## TECHNICAL MEMORANDUM

02 February 2026

# BENDIGO-OPHIR GOLD PROJECT RESPONSE TO TECHNICAL REVIEW

This memorandum responds to requests from the Otago Regional Council (ORC) in relation to the *Matakanui Gold Limited fast-track application for the Bendigo-Ophir Gold Project* and presents:

Figure 1 CIT: planned final pit configuration

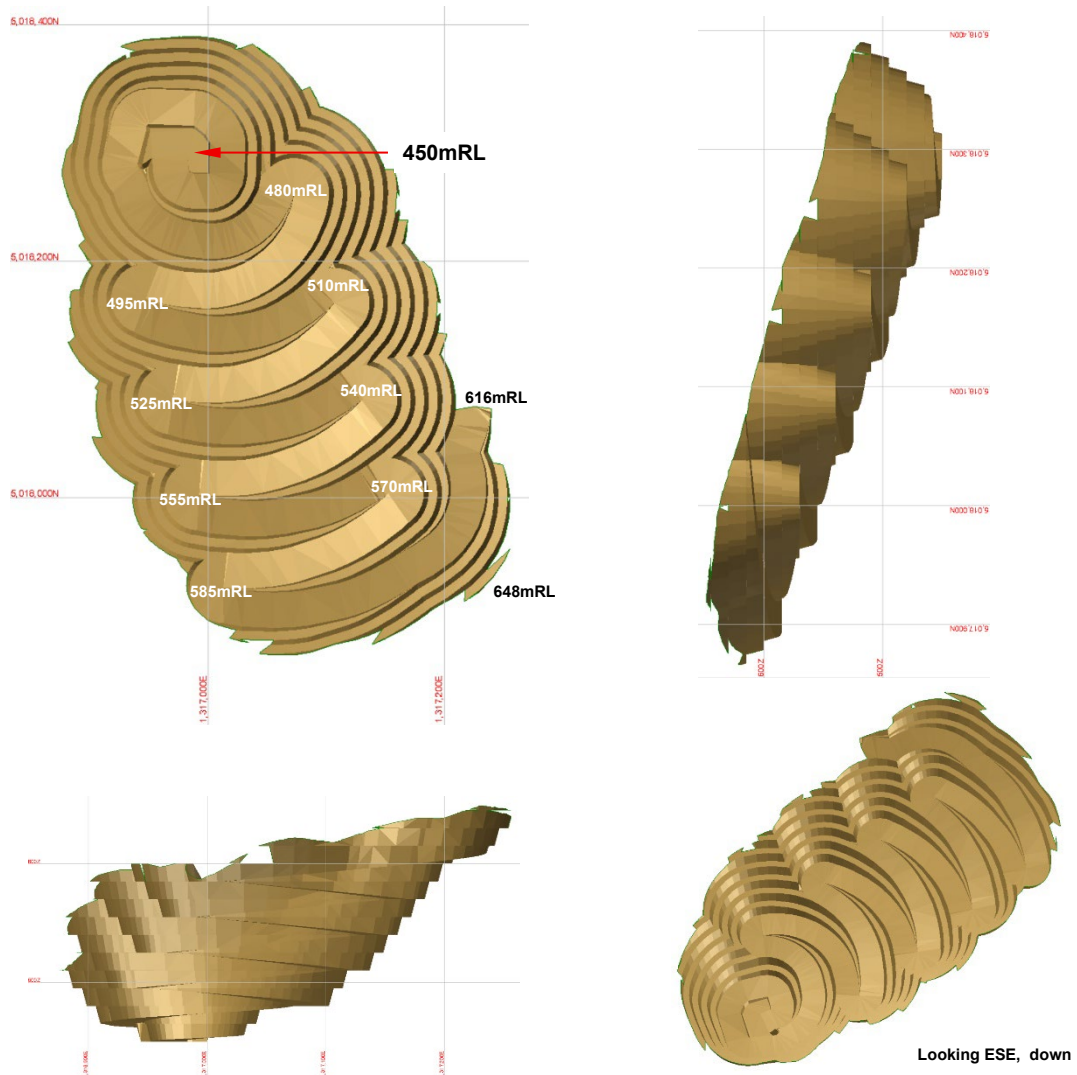
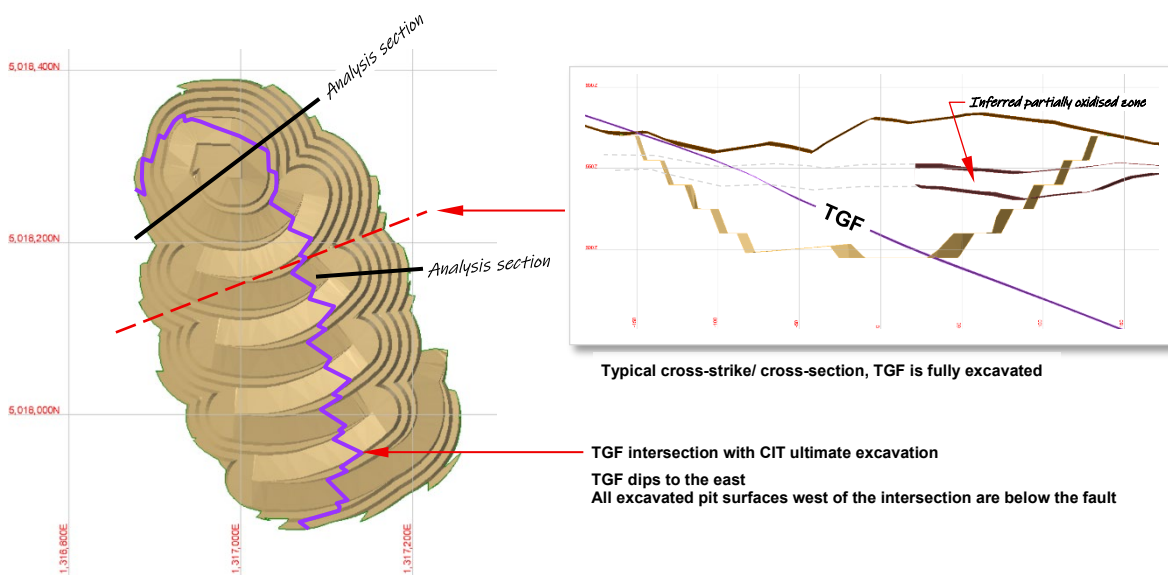
➡ The stability of the other pits does not appear to have been assessed at this stage.

On completion the CIT pit is to be fully backfilled. There is no possibility of disturbance to the DOC protected area from deterioration of CIT pit slopes. The pit is adjacent to the DOC protected area but at a stand-off great enough to prevent crest retreat in response to long-term deterioration the western pit slope reaching the DOC boundary.

The planned CIT open pit trends north north-west, sub-parallel to the strike of the TGF (Figure 1). The minimum floor elevation and highest walls are achieved in the northern sector of the proposed pit. Mining at CIT (Figure 2) largely excavates the TGF. The eastern wall will be formed dominantly in the TZ3 (hangingwall unit), with only localised exposure of TZ4 in the lowermost batters in the northern sector. The western wall will largely be within the TZ4, beneath the TGF, with only minor localised zones of the uppermost batters in the northern sector in TZ3. The TGF will be exposed only in the endwalls of the pit (which cut across the strike of the fault).

**Figure 5 Definition of ZOI & location of abandonment barrier**

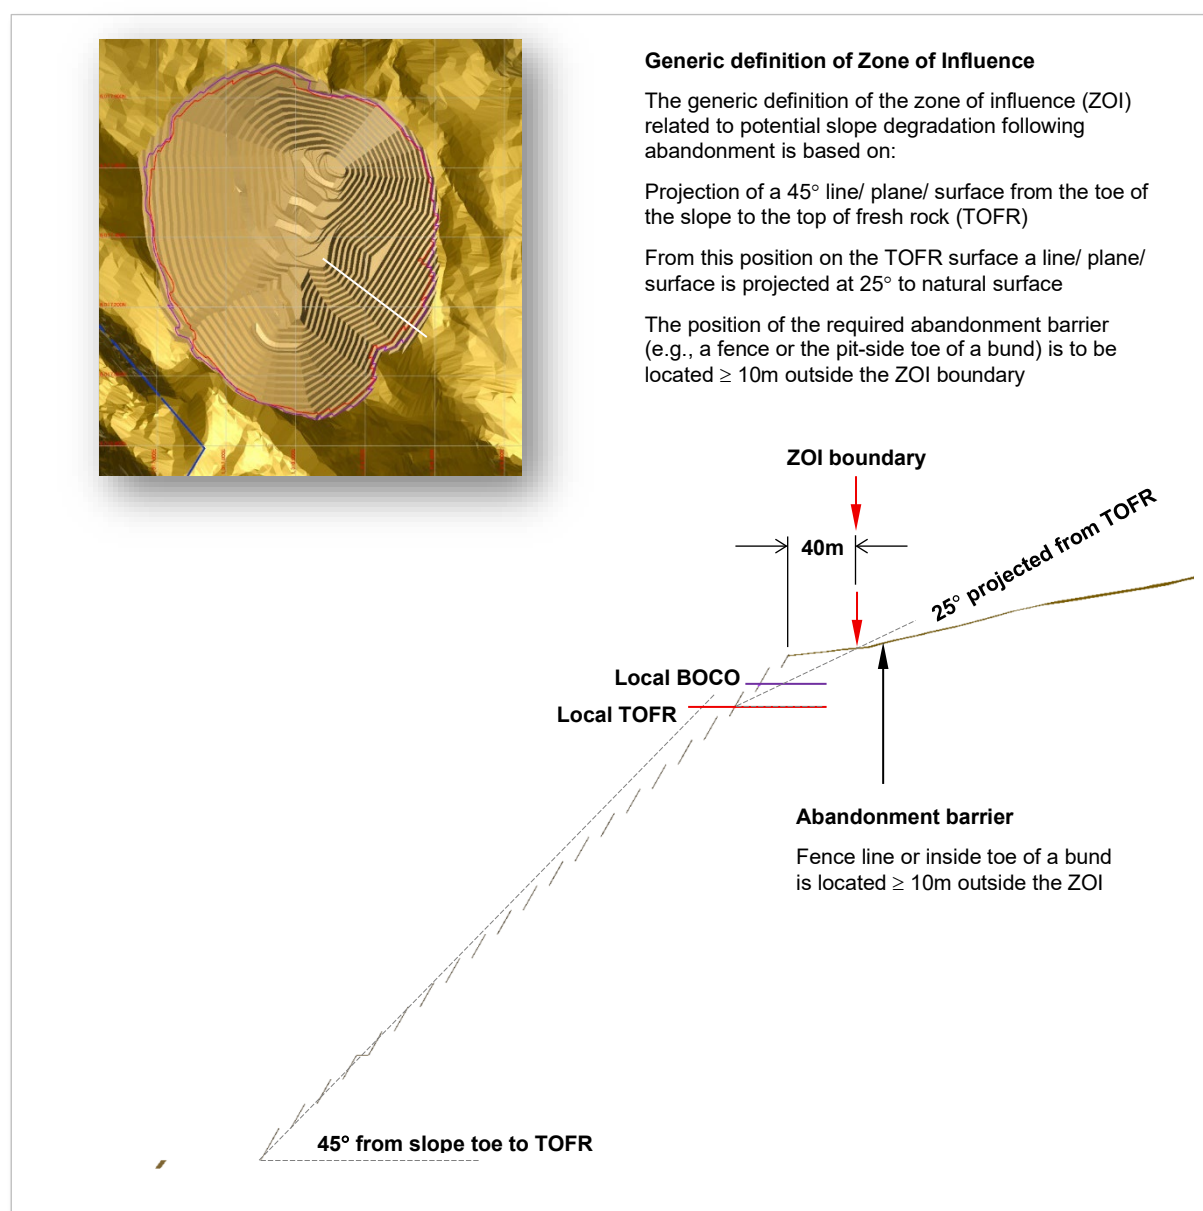
- ➡ As the RAS pit will not be backfilled, an exclusion zone around the pit must be established on abandonment as noted above to permanently restrict the public from approaching the pit edge.
- ➡ A further potential issue is the proximity of the pits to the DOC site boundary.  
A minimum FOS of 1.5 shall be maintained under static loading for all ground outside the site boundary, unless an alternative FOS is agreed in writing by the Consent Authority

In the absence of local guidelines, the Western Australian guideline for *Safety Bund Walls around Abandoned Open Pit Mines* # has been used for preliminary assessment of abandonment barriers for the RAS and SRX pits. The WA guideline is illustrated and described in Figure 5.

**Figure 8** SLIDE2D LE analysis models, Stage 7 predicted minimum FOS  
 LEA on this section is acceptable, since modelled TGF faithfully reflects true geometry

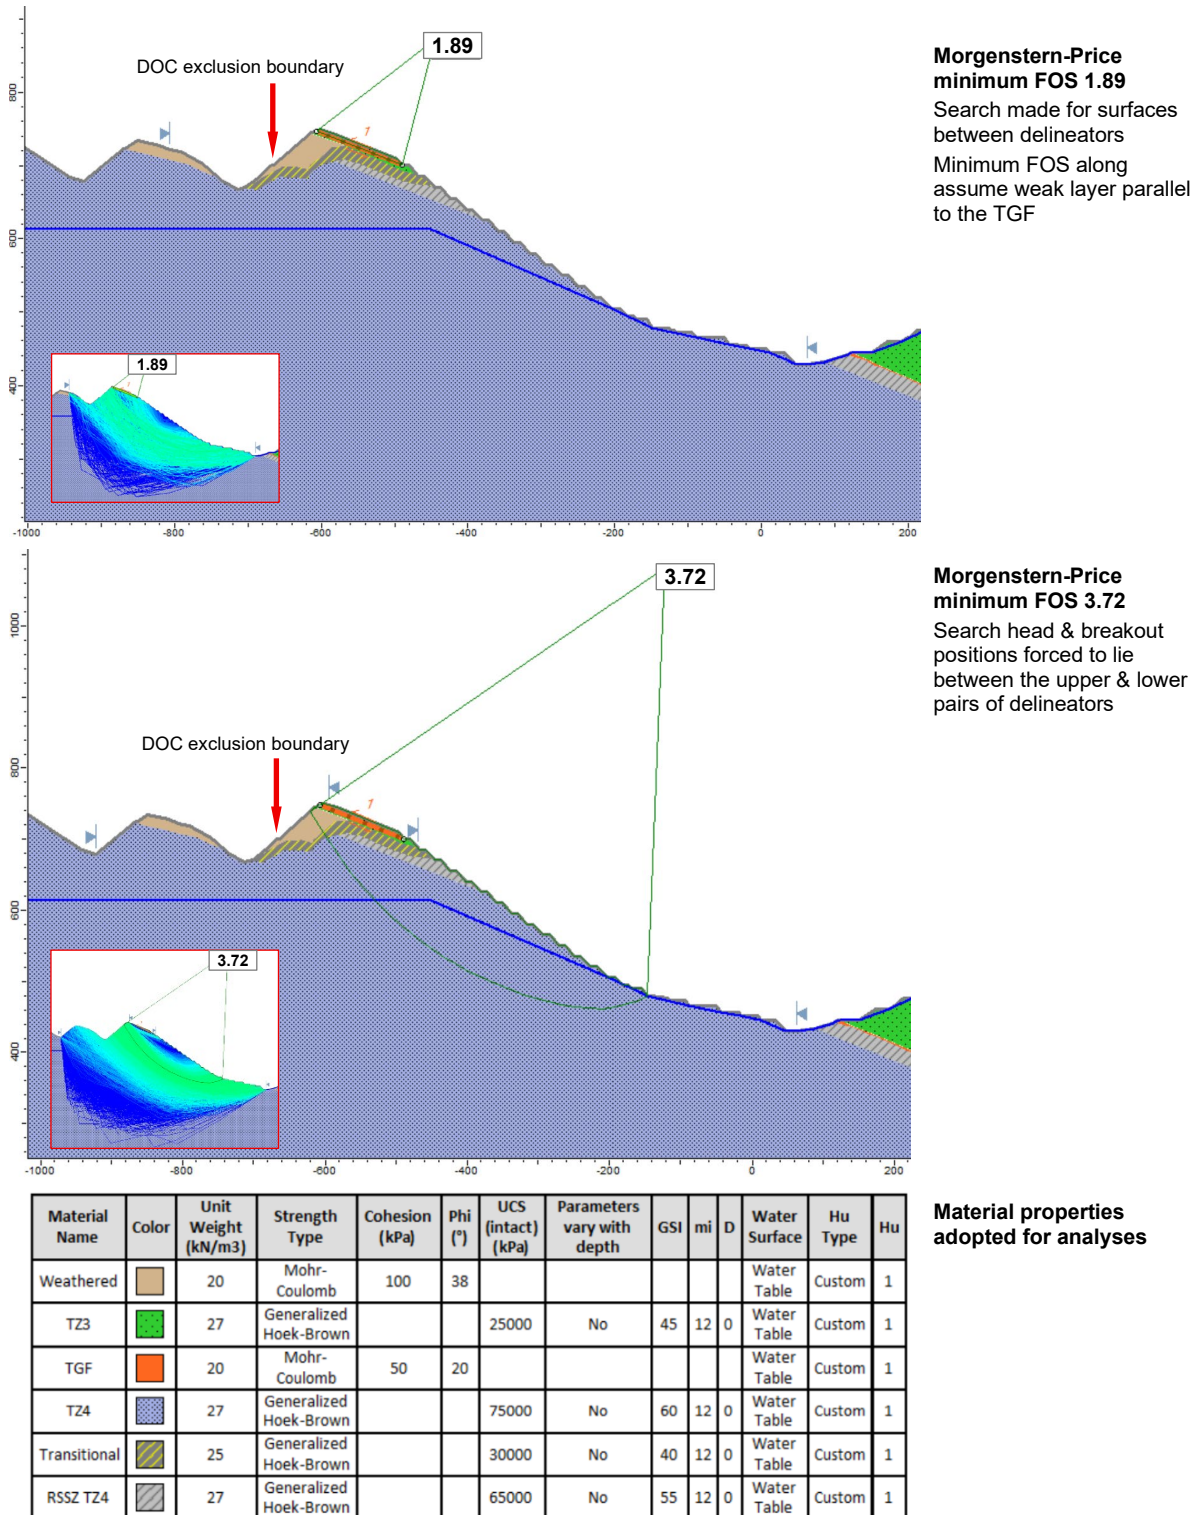
- ➔ In your response, please discuss the recommendations of GeoSolve:
1. A minimum FoS of 1.5 shall be maintained under static loading for all ground outside the site boundary, unless an alternative FoS is agreed in writing by the Consent Authority.
  - ➔ 2. Prior to excavation, the consent holder shall provide a geotechnical stability assessment prepared by a suitably qualified and experienced practitioner. The assessment must:
    - Model potential failure surfaces and assess FoS for areas outside the site boundary.
    - Identify any mitigation measures or monitoring required to maintain compliance.
  - ➔ 3. All stability assessments and monitoring reports shall be prepared by a suitably qualified chartered geotechnical or mining engineer.

Use of LE analysis is reasonable for this sector and returns acceptable results, illustrated in Figure 8. Minimum FOS values are well above 1.5 and there is no encroachment on or near the DOC boundary.
